***Northshore Mining Company  
Milepost 7 Tailings Basin***

***Five-Year Operations Plan  
Years 2004-2008***

***December 2003***

Figure 4

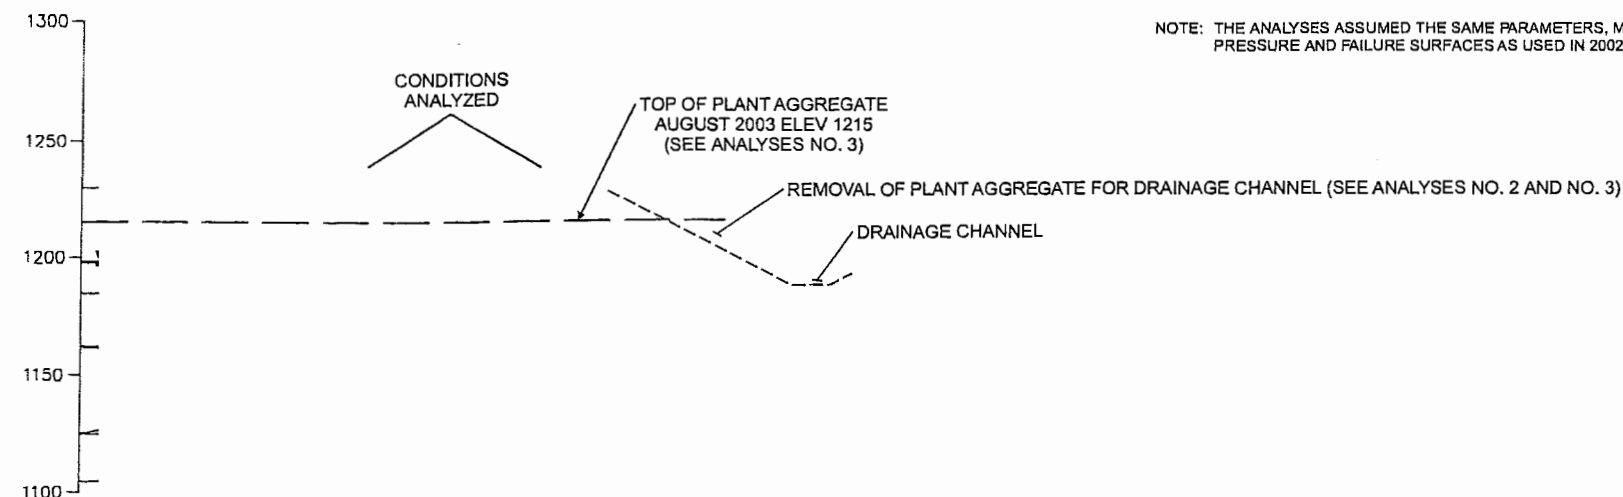
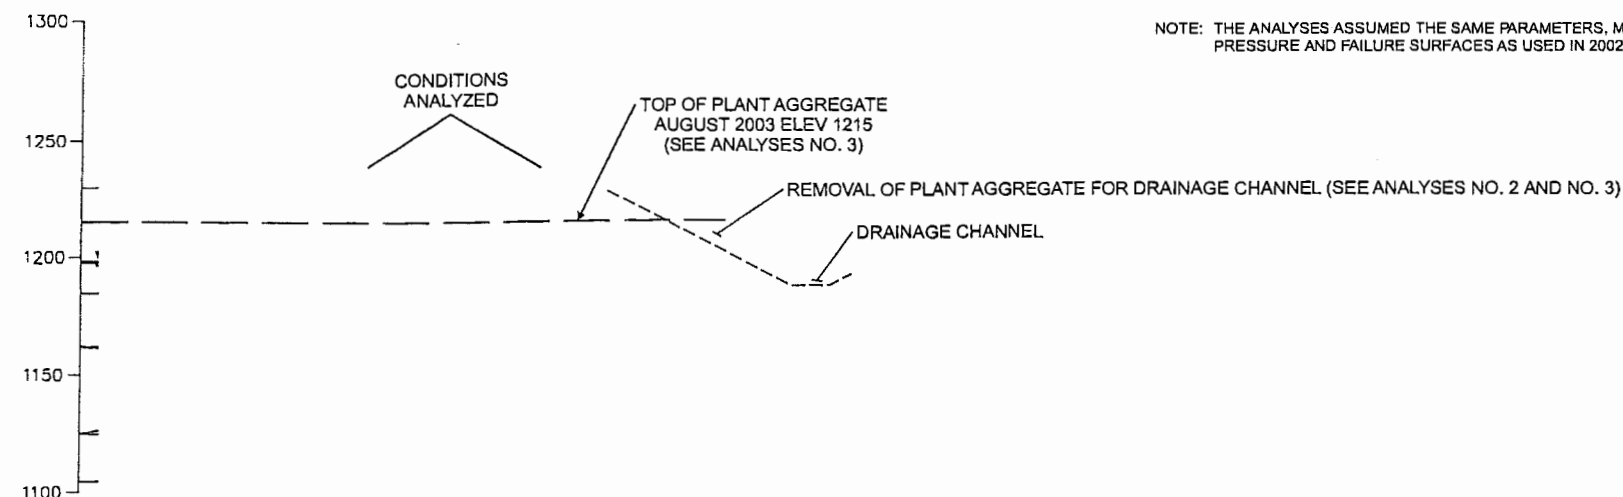
A comparison of the dams' factors of safety with the proposed drainage ditch in lieu of the toe berm is shown on attached Barr Drawing No. A-02. The analyses show that the factor of safety computed by Sitka in the 2002 Operating Plan for the typical section with a toe berm is similar to the factor of safety computed by Barr in 2003 with the proposed drainage ditch and no toe berm. The analyses performed by Barr assumed the same parameters, properties, piezometric pressures, and shear surfaces as the Sitka analyses (as presented in the 2002 Operating Plan) without consideration for appropriateness. Therefore, the results of the analyses are to be used only for comparison purposes of the dam's stability with the toe berm (Sitka) and with the drainage channel in lieu of the toe berm (Barr).

**Figure 3**

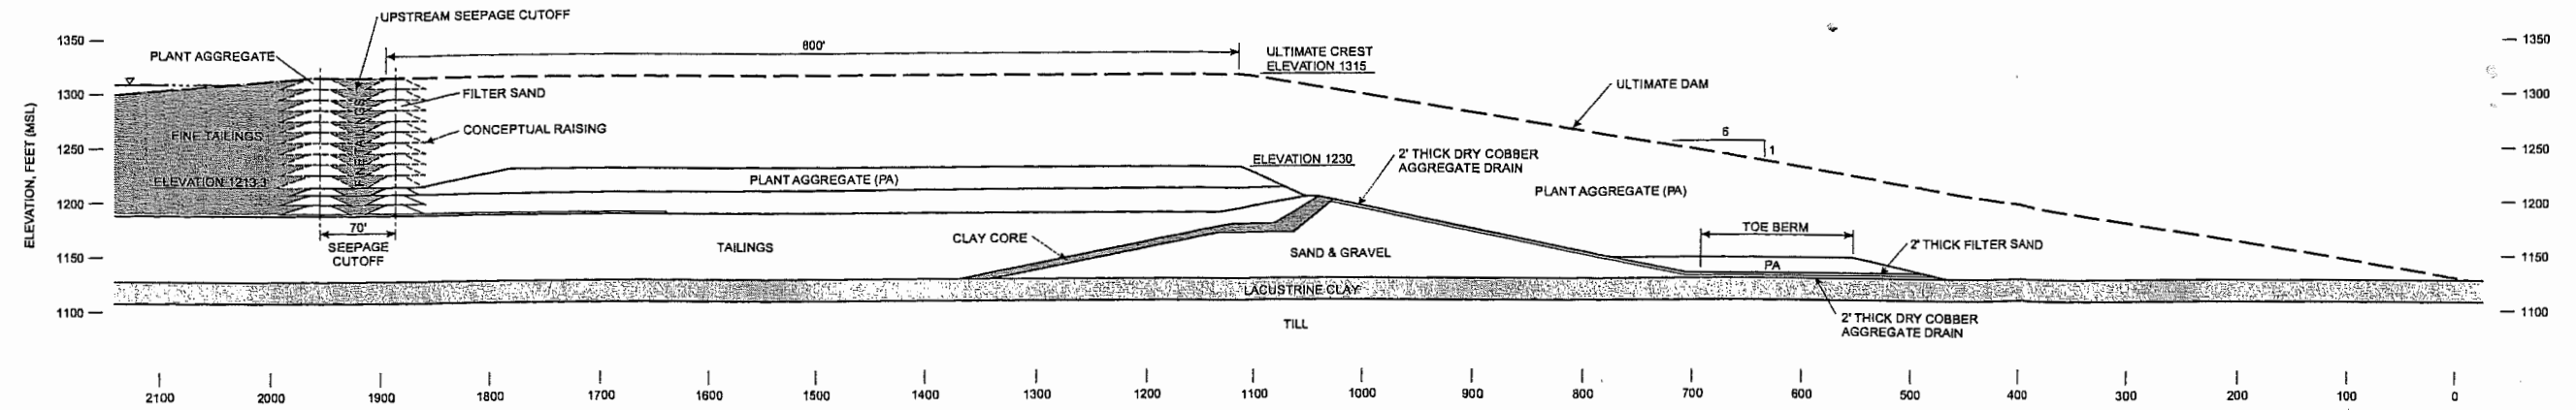
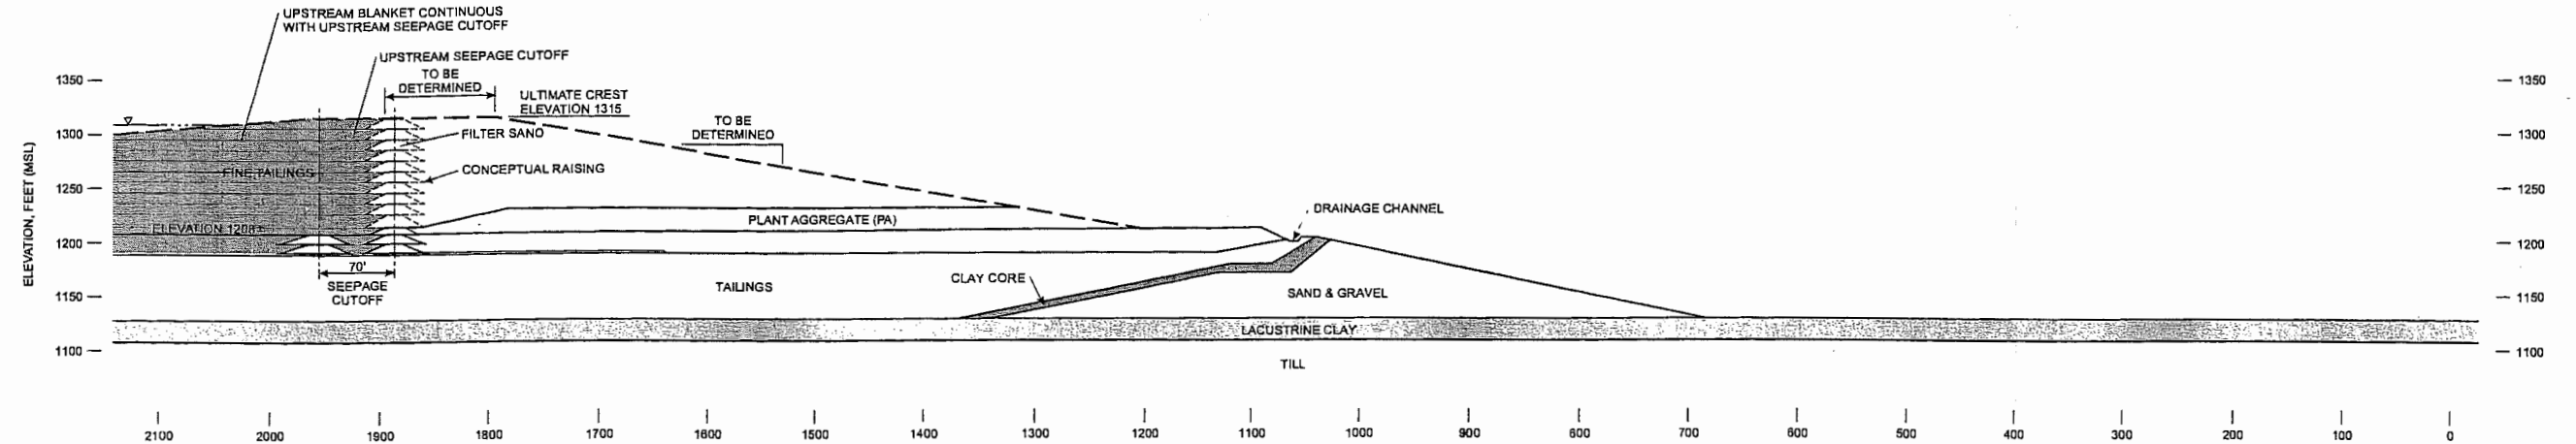
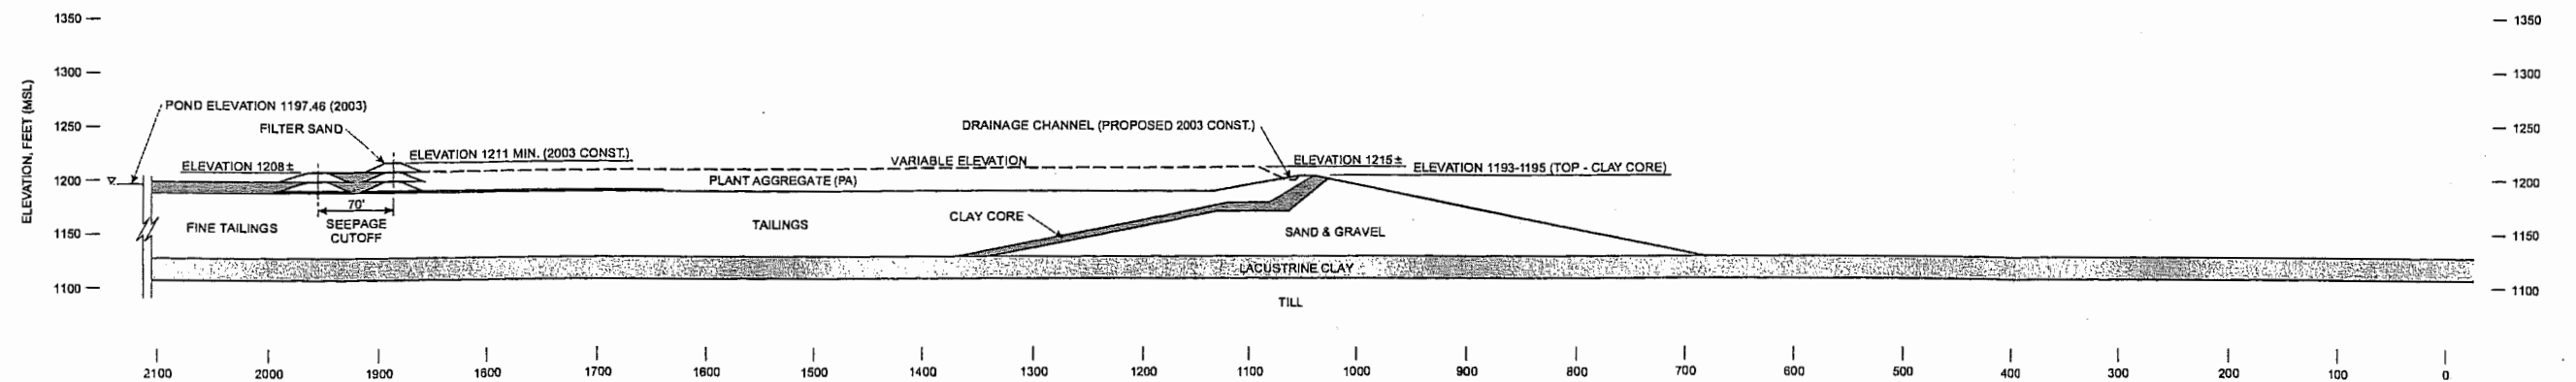
The proposed 2003 conceptual design changes to the typical tailings dam section are shown on attached Barr Drawing No. A-01 which shows the 2003 Typical Tailings Dam Section (long term) by Barr and the 2003 Barr Concept Plan of Existing Typical Tailings Dam Section (August 2003). To more easily review and compare the 2003 conceptual design changes, Barr Drawing No. A-01 also shows the 1997 Typical Tailings Dam Section (by Sitka, as presented in the 2002 Operating Plan, Drawing No. 1151). The 2003 conceptual design changes proposed by Barr consist of the following:

1. Modify Seepage Cutoff (upstream)—Elimination of the upstream berm of plant aggregate material on the seepage cutoff. The upstream berm of plant aggregate material as proposed by Sitka Corp. is shown on Sitka Drawing No. 1151 in the 2002 Operating Plan and is also shown on attached Barr Drawing No. A-01 along with the 2003 concept design proposed by Barr Engineering Co.

2. Construct New Drainage Ditch—Construction of a new drainage ditch along the upstream side of the clay core of the starter dam of Dam No. 1 and Dam No. 2 is proposed. The drainage ditch along the crest of the starter dams, as proposed by Barr Engineering Co., is shown on attached Barr Drawing No. A-01. Water from the drainage ditch will discharge into the seepage recovery ponds, the same as presented in the 2002 Operating Plan (by Sitka).

3. Eliminate Aggregate Drain (downstream slope of dam)—Elimination of the aggregate drain consisting of 2-foot-thick dry cobber material on the downstream slope of the starter dam shown on Sitka Drawing No. 1151 and also on attached Barr Drawing No. A-01. This aggregate drain will not be necessary since the drainage ditch proposed by Barr Engineering Co. will not allow water to flow over the crest of the starter dam.

4. Eliminate Toe Berm (along the downstream toe of the dam)—Elimination of the toe berm consisting of plant aggregate, 2-foot filter sand and 2-foot dry cobber aggregate drain shown on Sitka Drawing No. 1151 and also on attached Barr Drawing No. A-01. This toe berm is not

necessary since similar factors of safety are achieved by constructing the drainage ditch upstream of the clay core and removing the plant aggregate material from the crest of the dam.
